Date: August 16, 02
 To: T10 Technical Committee
 From: Jim Coomes (jim.comes@seagate.com)
 Subject: Bit order for scrambling and CRC

Below are C programs and equations to generate CRC and scrambled output for Annex A and C in the SAS draft. This revision includes an example scrambler diagram, changes sample scramble code to a serial shift register, scrambled data output for all zeros input, and example XOR equations for generating a 32 bit scramble value.

Data scrambler implementation example

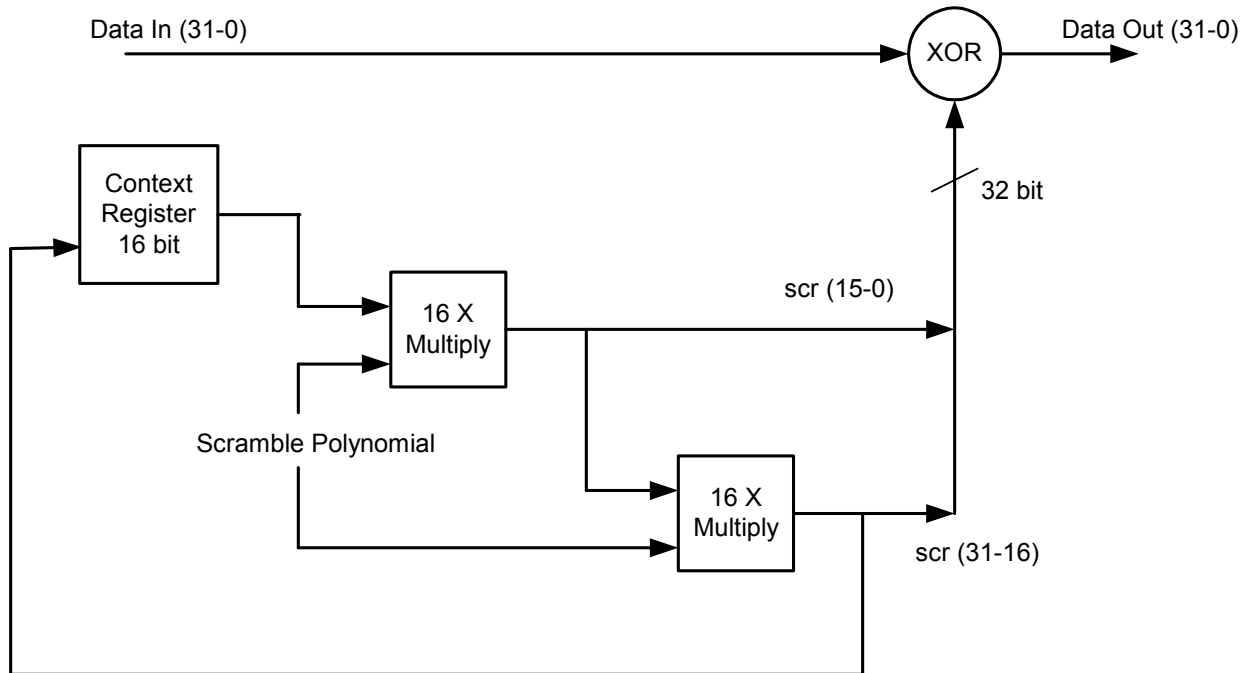
Figure xx shows an example of a data scrambler. This example generates the value to XOR with the dword input with two 16 bit parallel multipliers. 16 bits wide is the maximum width for the multiplier as the generating polynomial is 16 bits.
